# Product Change Notification

- 5569 Series
  - Mini-Fit Jr.

Before Picture

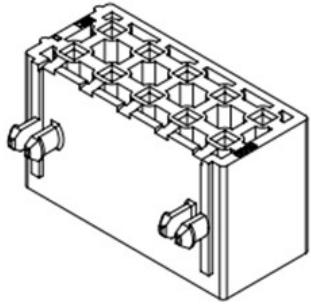
<b>Date Issued :</b>	September 07, 2022	<b>PCN Number :</b>	512554
<b>Reason for Change :</b>	Capacity change or tool replacement		
<b>Description of Change :</b>	This notice is to inform you that Molex Lincoln Nebraska is adding additional tooling that will affect the product listed. New tooling will be exact replica of current tooling. There will be no change to the product Fit, Form, Function or Appearance when compared to current tooling.		
<b>Reason for Short Notice :</b>	Capacity Increase		
<b>Assessment of Change :</b>	Dimension analysis		
<b>Planned Implementation Date :</b>	November 01, 2022		
<b>Sample Availability Date:</b>	October 07, 2022		
<b>Internal Molex Qualification Date :</b>	October 07, 2022		
<b>Last date to request Samples by Customer :</b>	October 18, 2022		
<b>Traceability Code Markings / Date :</b>	Product made after planned implementation date can contain the change

- To ensure business continuity, Molex Lincoln Nebraska is adding another set of tooling
  - New tooling will be an exact replica of current tooling
  - Tooling being added to keep up with current and future demand
- There is NO impact to Fit, Form or Function
- Samples available upon request after date shown above
- Part Numbers Impacted
  - See attached list
